**VOLUME 1 - MAIN REPORT**  
**PREFERRED PROJECT REPORT**  
**MATERIALS RECYCLING FACILITY**  
**LOTS 308, 309 & 310, DP 1118048**  
**LOT 6, DP 1065574**  
**NEWBRIDGE ROAD**  
**MOOREBANK**

15 August 2013

**Figure 2-3:** 19 metre Semi-Articulated vehicle left turn into driveway from median (third) lane tested at 10 km/h. Dark blue is the path of the tyres, light blue is the vehicle body and red is 300mm clearance.

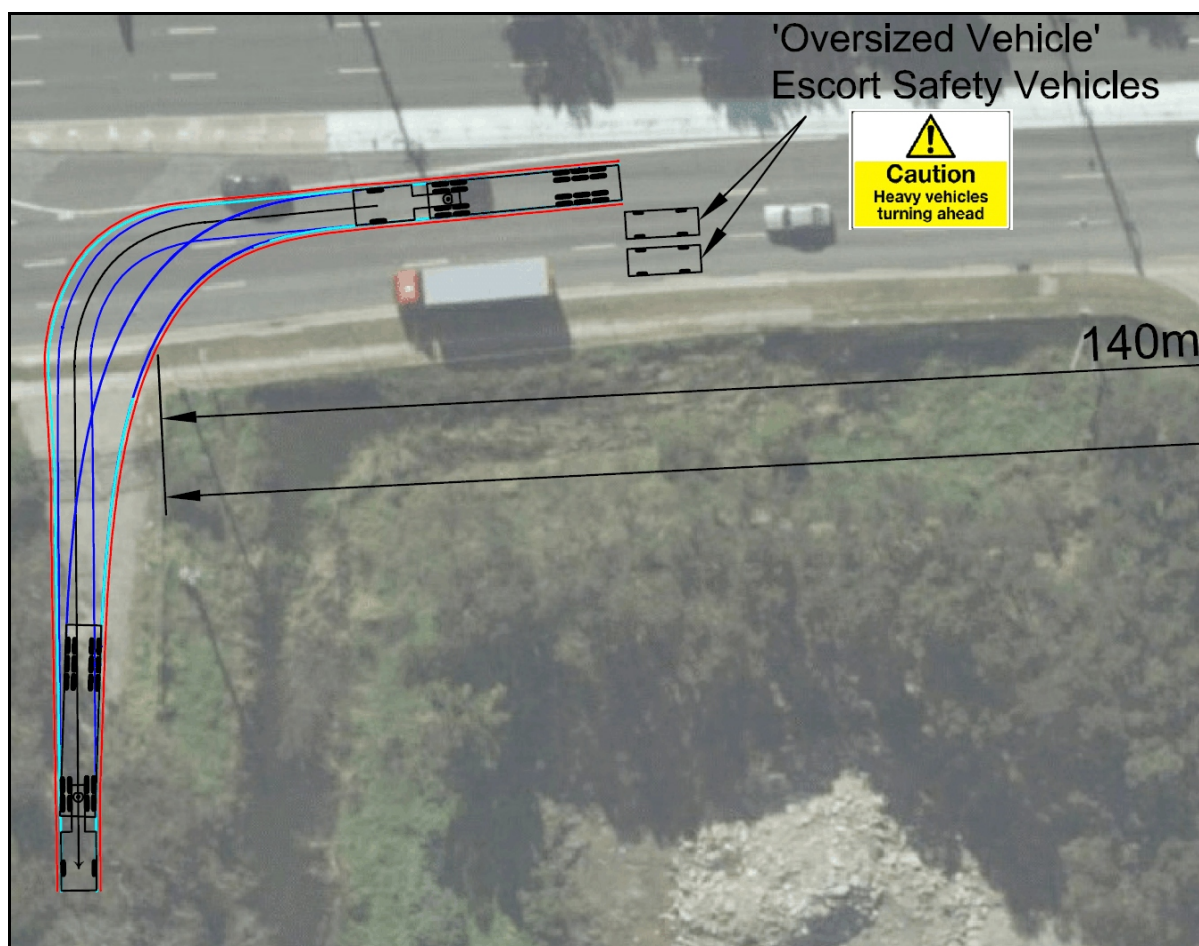
- *Turning paths shown on plan 8318/09 sheet 1D of 8 do not comply with Austroads Guide.*

The details of a low frequency event of construction related semi-trailers (Articulated Vehicles (AV) turning left off Newbridge Road is shown in **Figure 2-3** (AV in accordance with AS2890.2:2002).

It is evident that a MRV will need to turn from the middle lane of Newbridge Road which is acceptable under the Australian Road Rules. In relation to the AVs, these vehicles will be required to turn from the third lane of Newbridge Road under a two escort vehicle control traffic management plan, unless a driveway splay can be constructed as shown on **Figure 2-6** to assist the left turn entry movement. The two escort vehicles would drive at low speed in each of the inner lanes and the AV would travel in the third/central lane. The AVs would be time managed to only enter and leave the Site after weekday commuter peak periods, thus being directed to use Newbridge Road between the hours of 10:00 am to 3:00 pm on weekdays. As only one (1) AV is expected to arrive/depart the Site on weekdays, this is readily manageable.
